**MEETING OF THE
PLANNING AND ZONING BOARD
QUASI-JUDICIAL PUBLIC HEARING**

August 4, 2015

**TOWN OF BAY HARBOR ISLANDS
COMMUNITY DEVELOPMENT
MEMORANDUM**

Subject: PUD / Gateway – Site Development Plan Application
Grand Beach Hotel (formerly Bay Harbor Inn) – 99 Room Hotel
9601 East Bay Harbor Drive
Bay Harbor Islands Acct. No. MB2015-39
MMPA Acct. No. 01-0702-1009

1
A-629
1st FLOOR PLAN
SCALE: 3/16" = 1'-0"

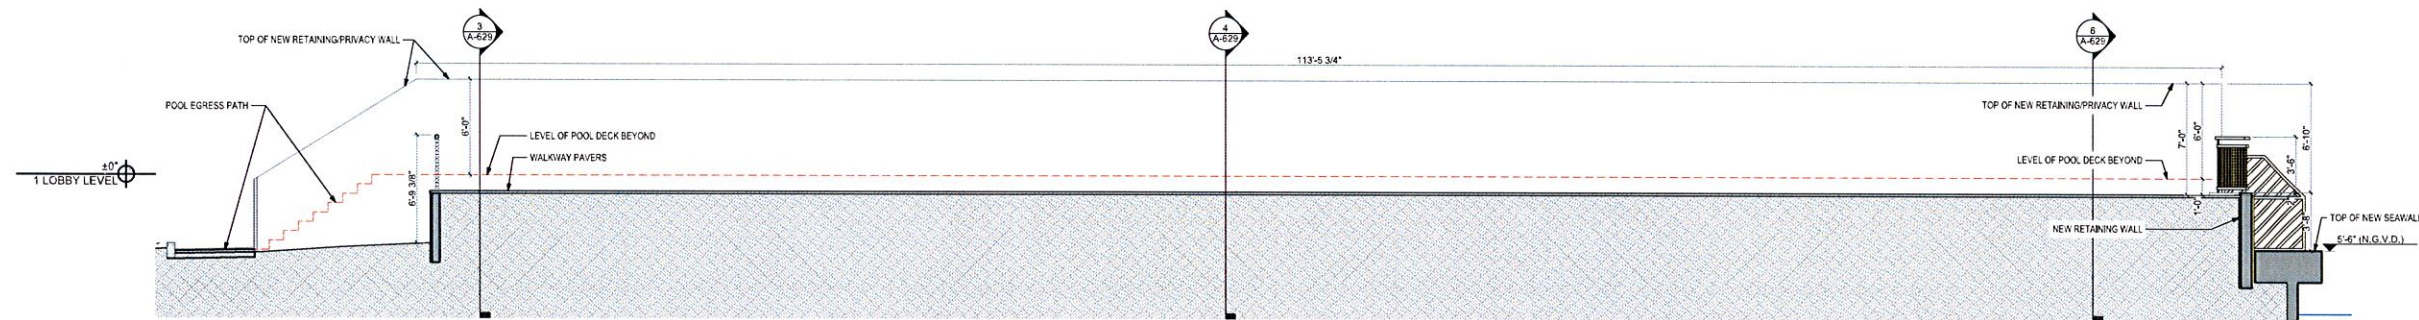
COMMENTS	DESCRIPTION
Comment 1	Can benches be added to the public promenade.
Response:	Benches have been added to the plans.
Comment 2	Work on the garage doors and 2 large louvers on West façade.
Response:	Garage doors drawings have been updated to better reflect the actual doors to be installed. The large louver on the north side has been completely removed. The large louver on the south side had been concealed by additional landscaping.
Comment 3	Review East elevation and try to break up the flat façade by adding some type of articulation..
Response	Some balconies have been recessed and new planters added on balcony edge.

A-312	Balcony recesses with planters on East façade.
A-629	Benches added to public promenade
A-702	Benches added to public promenade
L-302	Vines added to the north by the garage and additional sago palms added in south planter
L-303	Balcony recesses with planters on East façade.
L-304	Balcony recesses with planters on East façade.
L-305	Balcony recesses with planters on East façade.
L-306	Balcony recesses with planters on East façade.
L-307	Balcony recesses with planters on East façade.
L-308	Balcony recesses with planters on East façade.
L-309	Additional sago palms added in south planter
L-310	Vines added to the north by the garage and additional sago palms added in south planter
L-313	Balcony recesses with planters on East façade.

A-702
SCHEDULES &
DIAGRAMS
DATE
7/15/2015

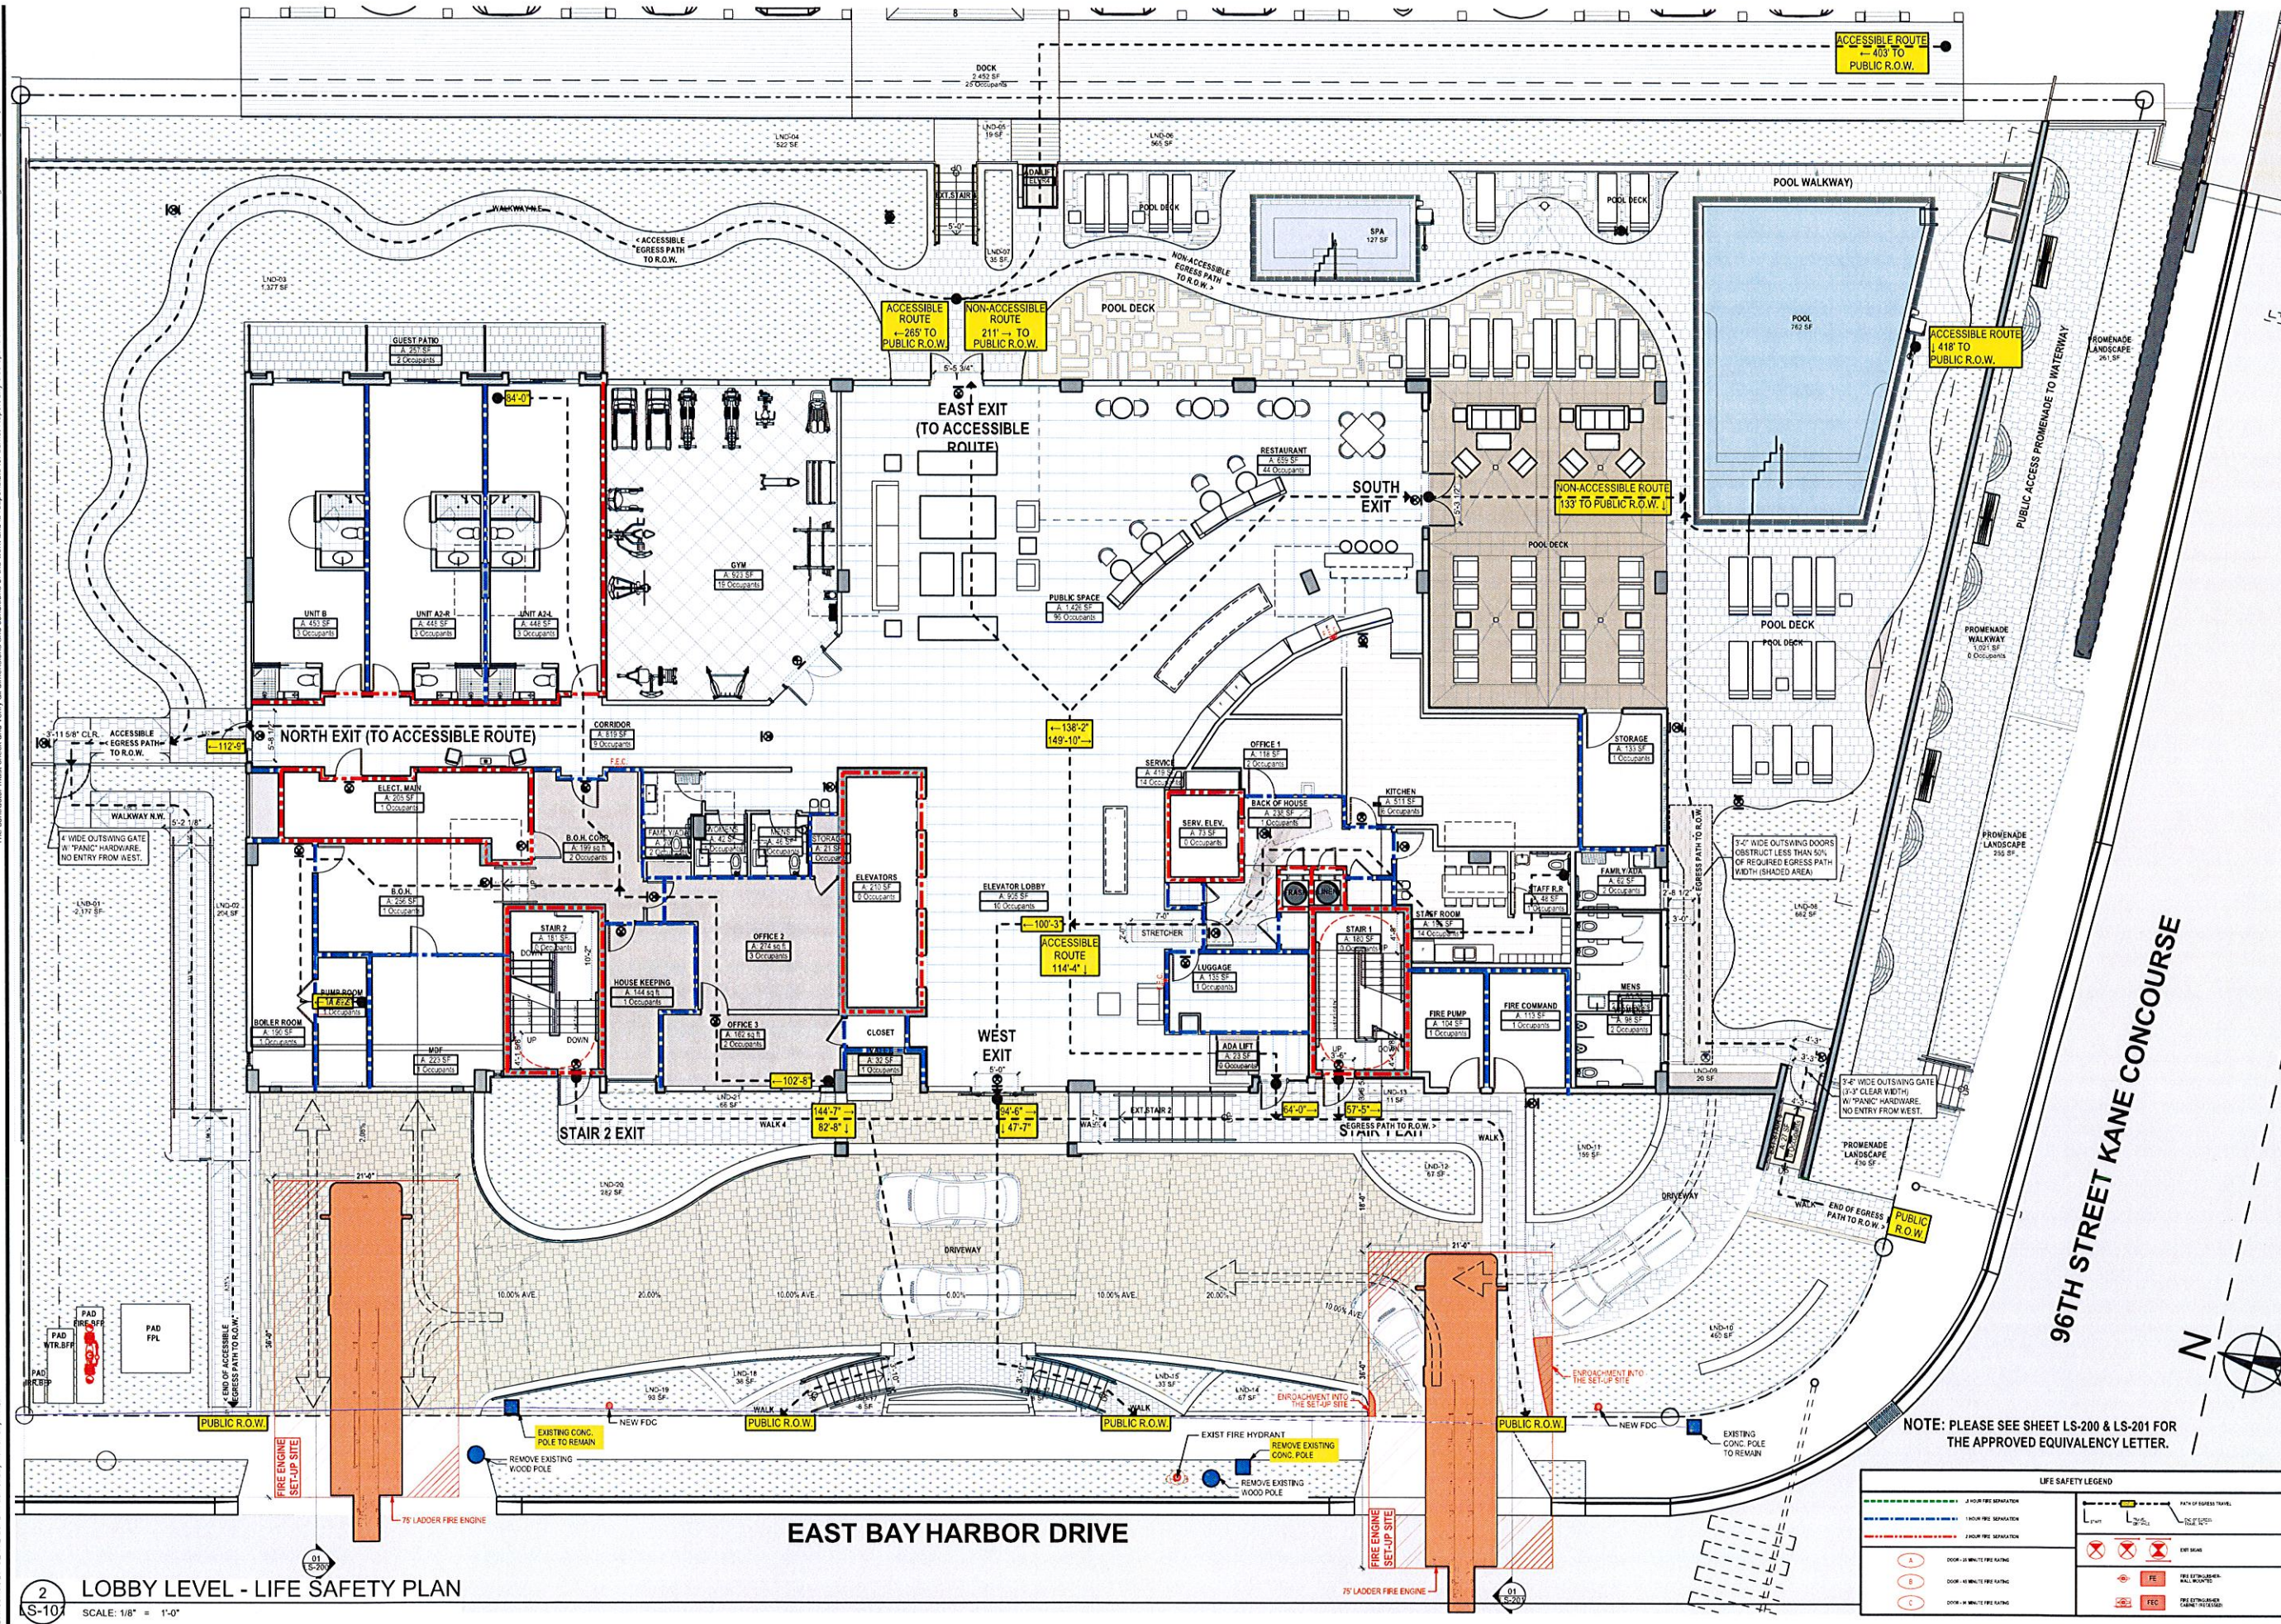
1. Provide greater articulation to the east façade. The applicant has staggered the depths of the balconies slightly as well as added some wooden accents to break up the façade.
2. Add benches to the pedestrian promenade. The applicant has added three benches to the pedestrian promenade.
3. Dress-up the land uses / building façade of the corner of the building (EBHD & 96th Street). The applicant has provided greater landscape screening.
4. Address the unattractive garage vent louvers at ground level facing EBHD. The applicant has moved one of the garage vents to the north façade as well as significantly reduced the size. The other garage vent has been screened with increased landscaping.
